SUNDRY NOTICES AND REPORTS ON WELLS

8. Well Name and No.
BIG SINKS 1 W1PA FED COM 2H

Mewbourne Oil Co. requests approval to make the following changes to the approved APD:

**** BLM REVISED ** BLM REVISED ** BLM REVISED ** BLM REVISED ** BLM REVISED ****

5M BOPE & Closed Loop Equipment Schematic

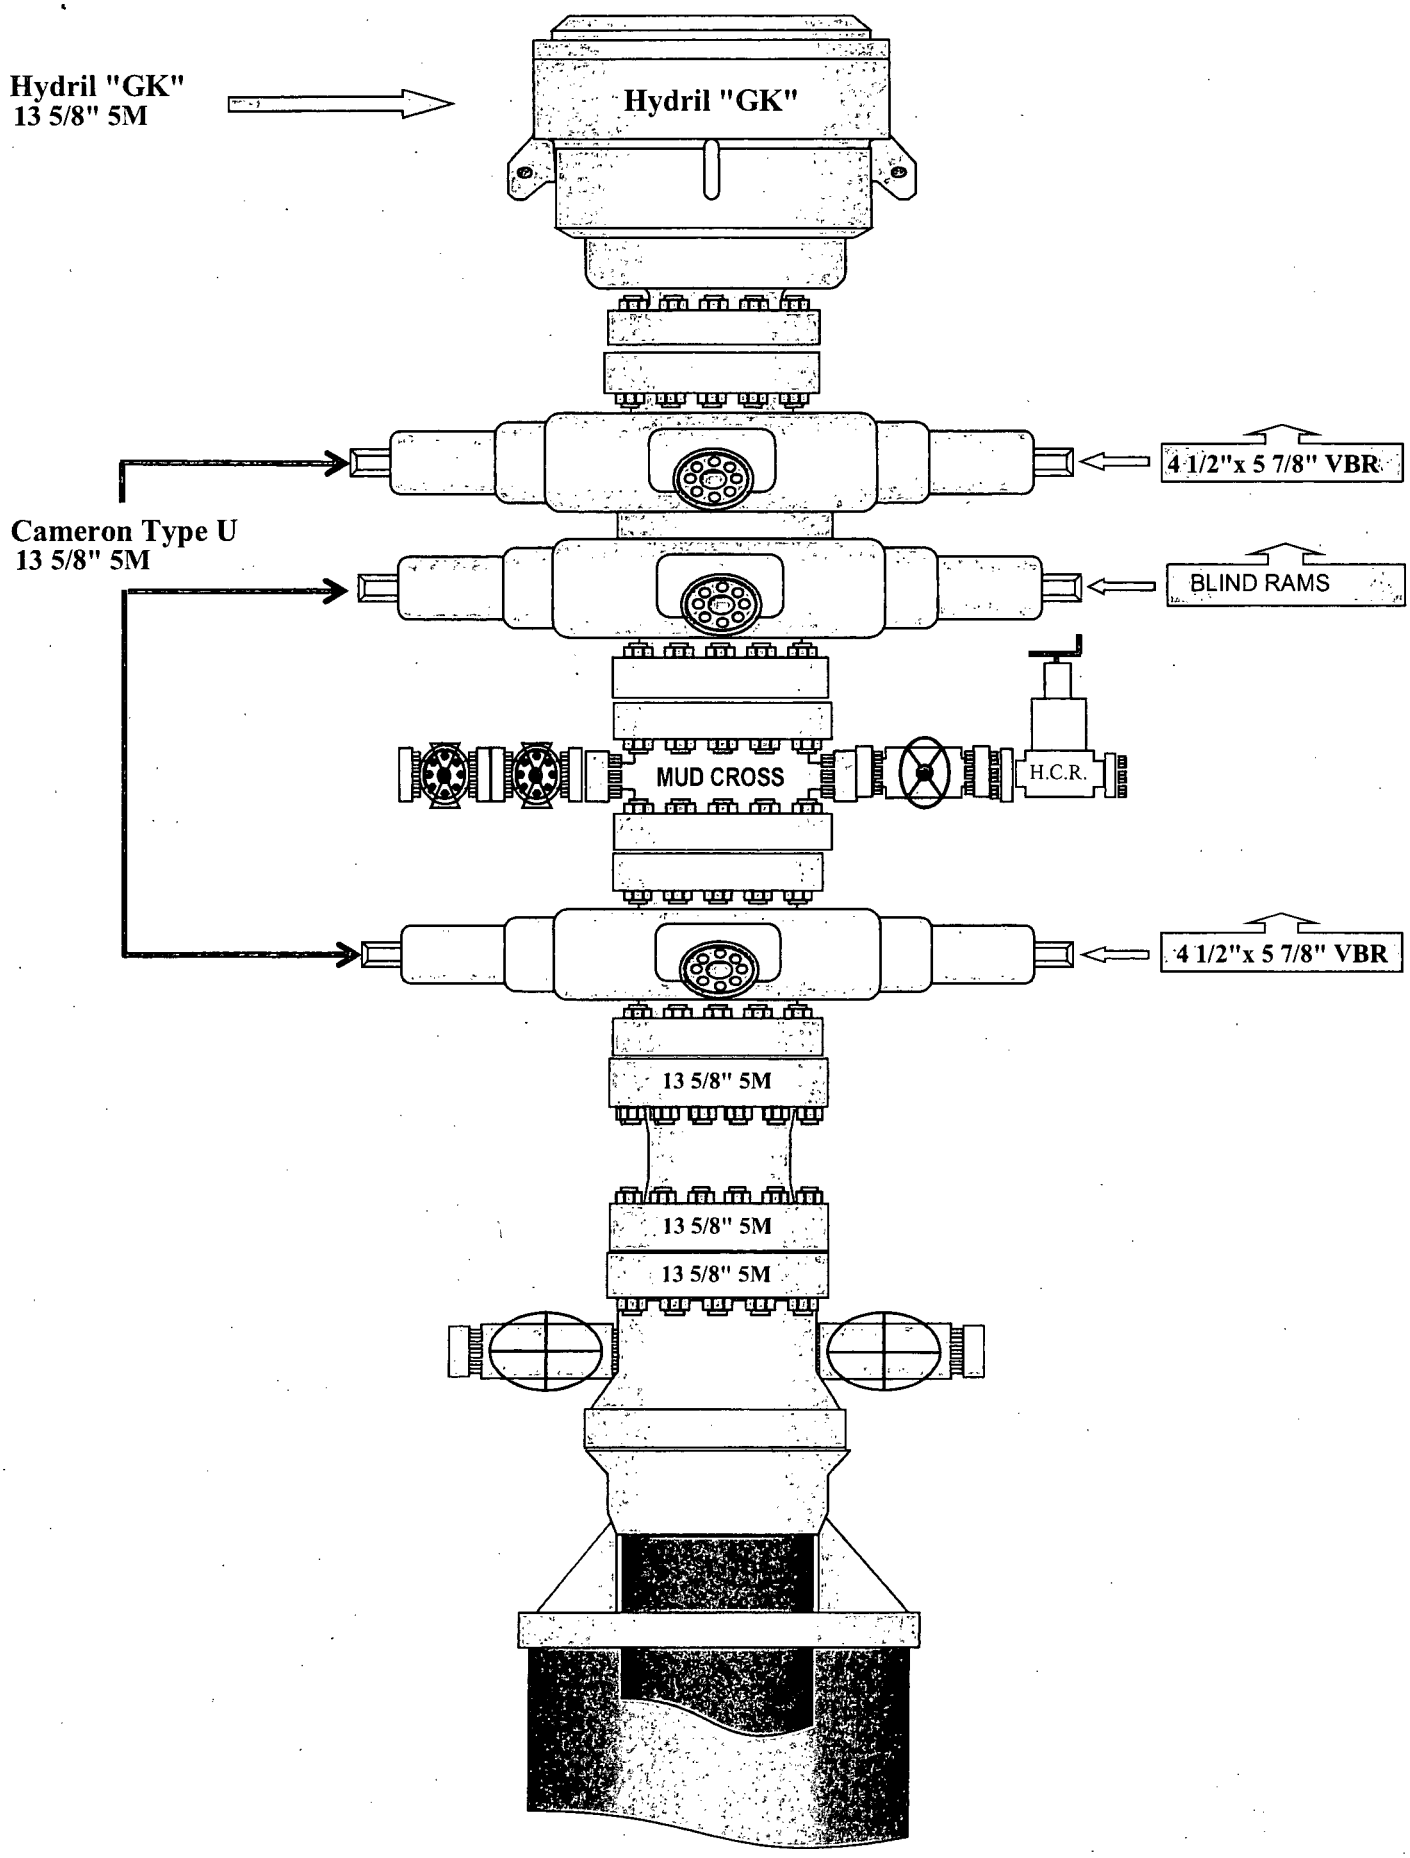
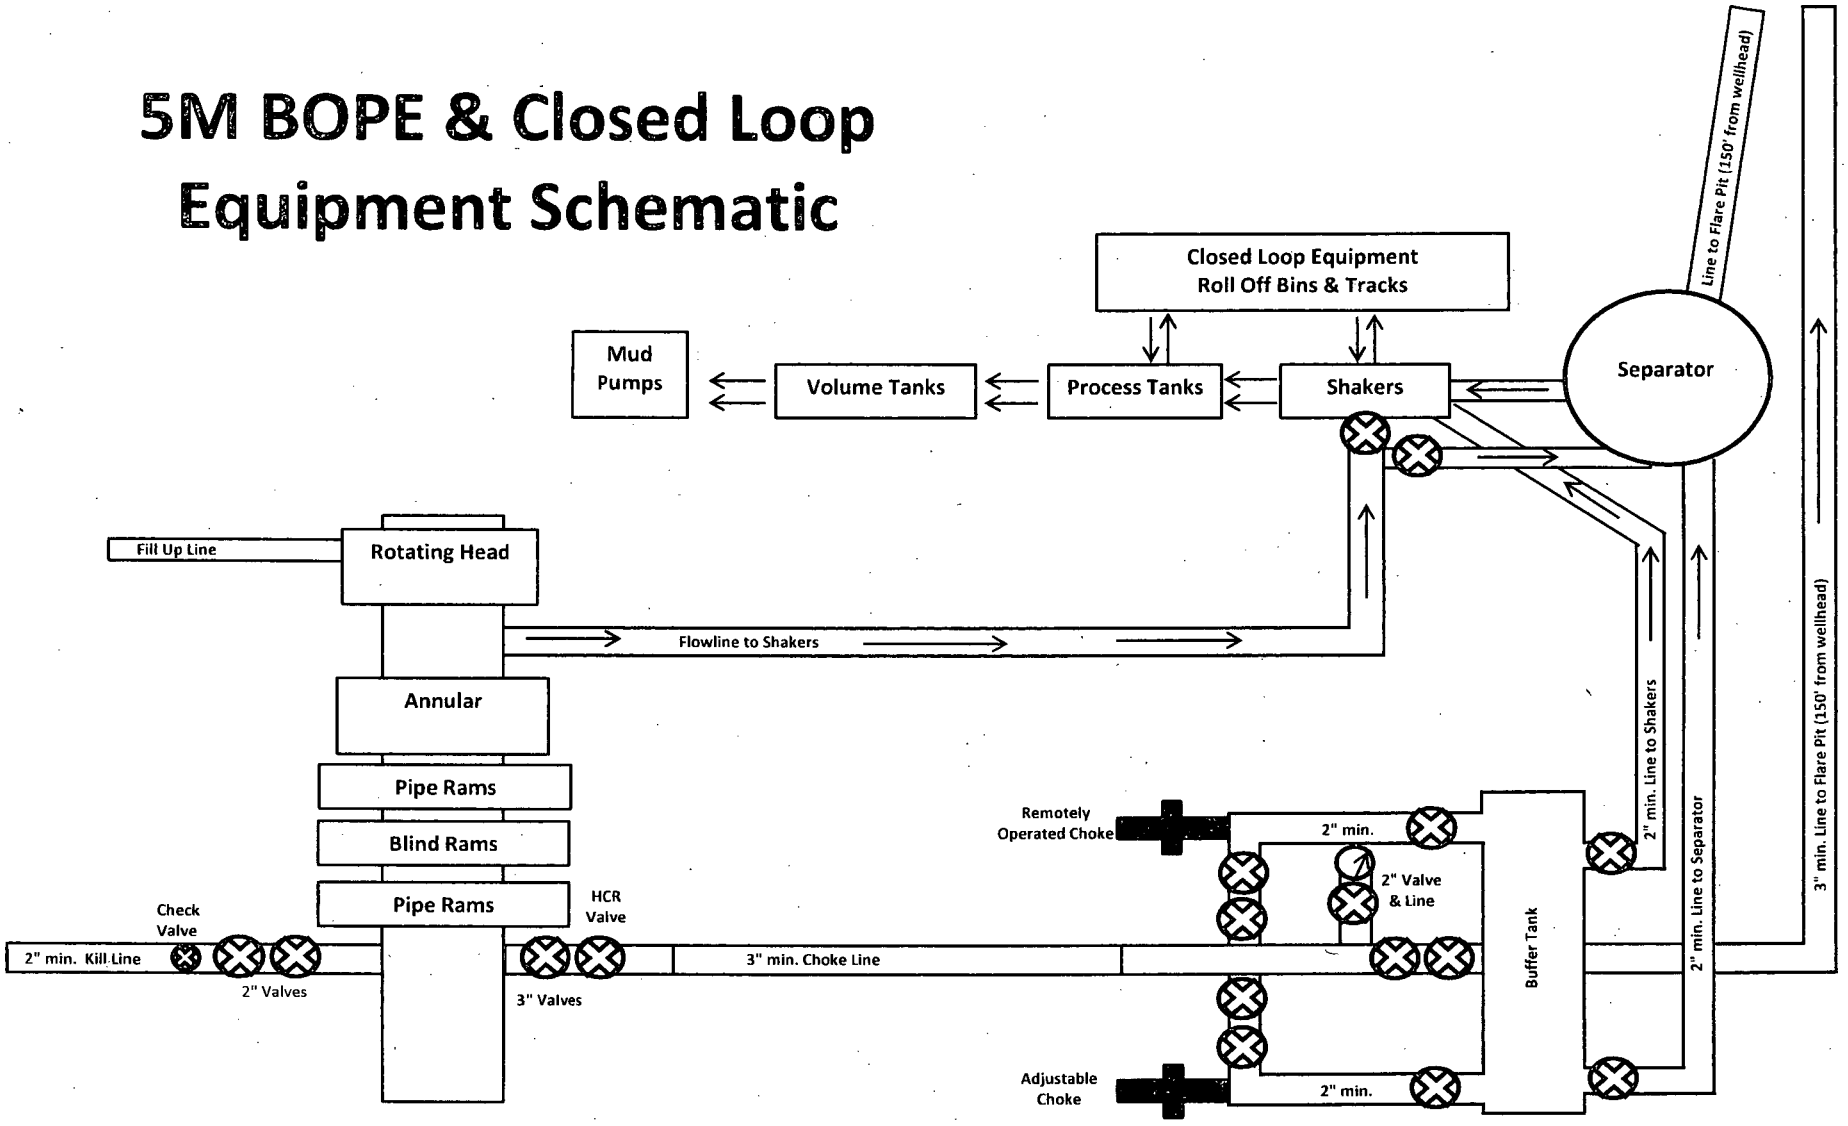
Pipe rams will be operationally checked each 24 hour period. Blind rams will be operationally checked on each trip out of the hole. These checks will be noted on the daily tour sheets. Other accessories to the BOP equipment will include a Kelly cock and floor safety valve (inside BOP) and choke lines and choke manifold. See attached schematics.

Manifold. See attached for specs and hydrostatic test chart.
	N Are anchors required by manufacturer?
N	A multibowl wellhead is being used. The BOP will be tested per Onshore Order #2 after installation on the surface casing which will cover testing requirements for a maximum of 30 days. If any seal subject to test pressure is broken the system must be tested. • Provide description here See attached schematic.

2. Variance approved to use flex line from BOP to choke manifold. Check condition of flexible line from BOP to choke manifold, replace if exterior is damaged or if line fails test. Line to be as straight as possible with no hard bends and is to be anchored according to Manufacturer's requirements. The flexible hose can be exchanged with a hose of equal size and equal or greater pressure rating. **Anchor requirements, specification sheet and hydrostatic pressure test certification matching the hose in service, to be onsite for review. These documents shall be posted in the company man's trailer and on the rig floor.** If the BLM inspector questions the straightness of the hose, a BLM engineer will be contacted and will review in the field or via picture supplied by inspector to determine if changes are required (operator shall expect delays if this occurs).

Big Sinks 1 W1PA Fed Com #2H
Section 1
BHL: 330' FNL & 330' FEL, Sec 1
FTP: 330' FSL & 330' FEL, Sec 1
Hard Lines
LP: 108' FSL & 330' FEL, Sec 1
KOP @ 11499'
SL: 465' FNL & 330' FEL, Sec 12
Section 12
South(-)/North(+) (2500 usft/in)
West(-)/East(+) (2500 usft/in)

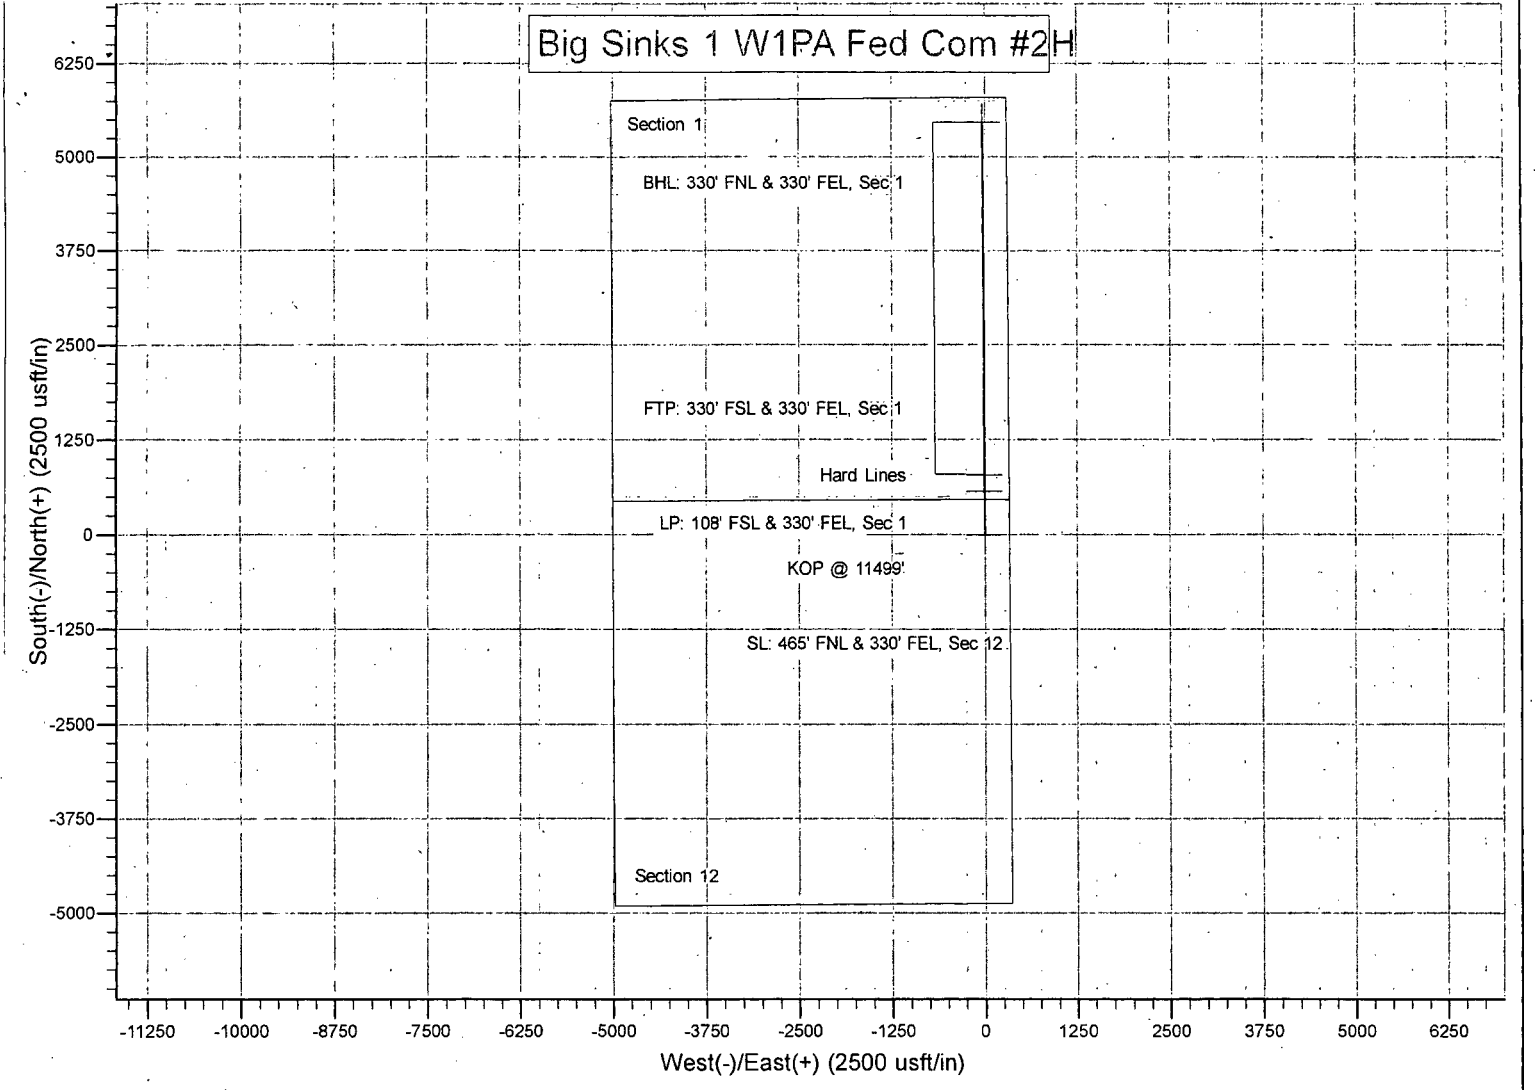
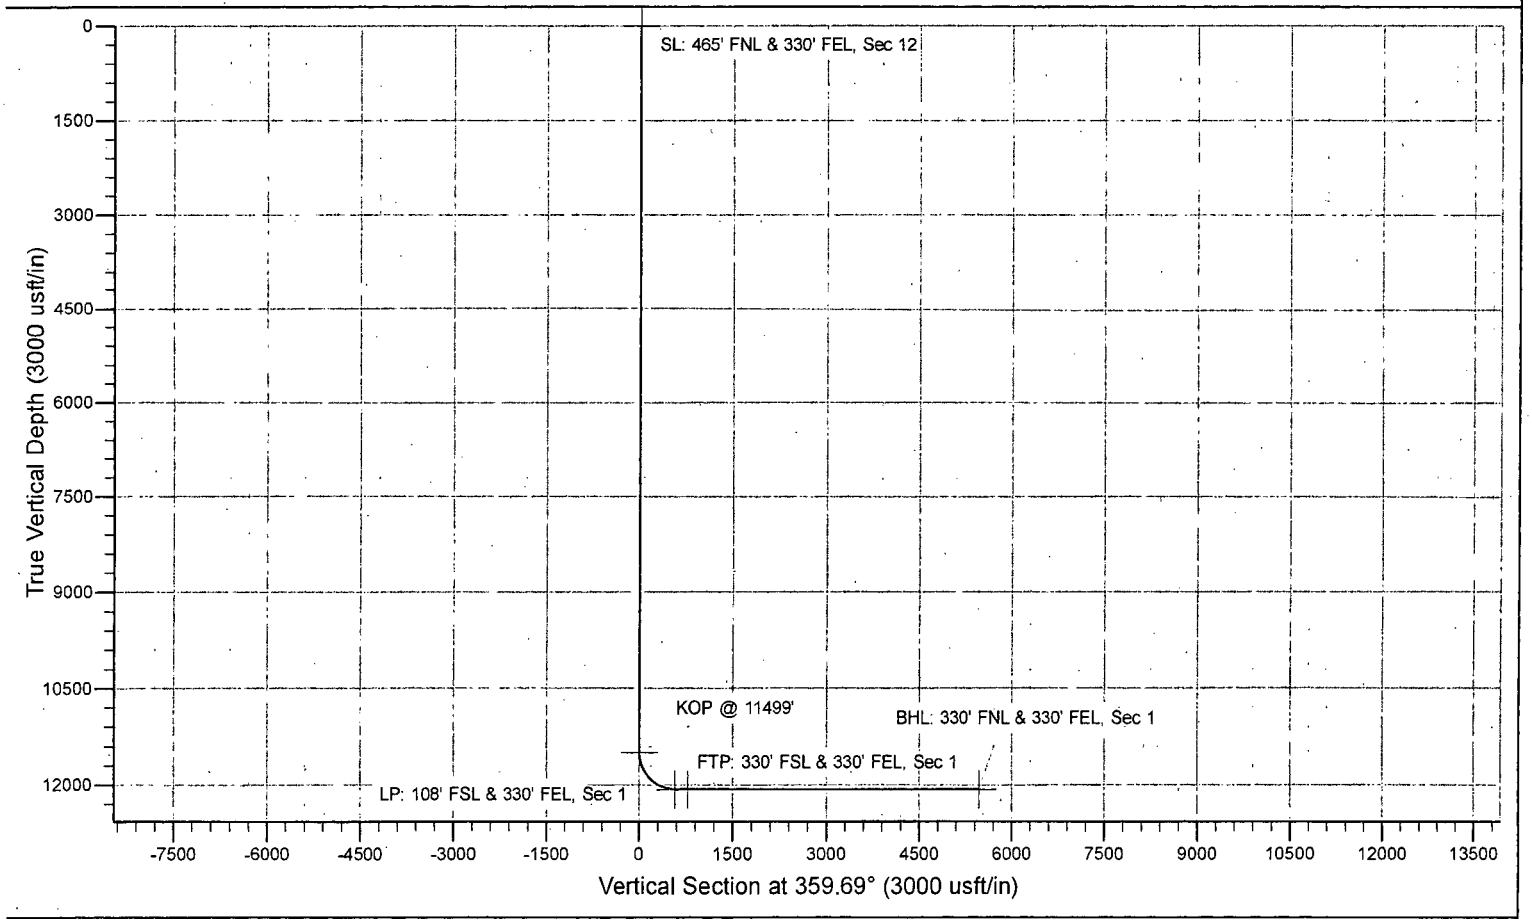
Change target zone to Wolfcamp & TVD to 12,072'. See attachments for new drilling plan.
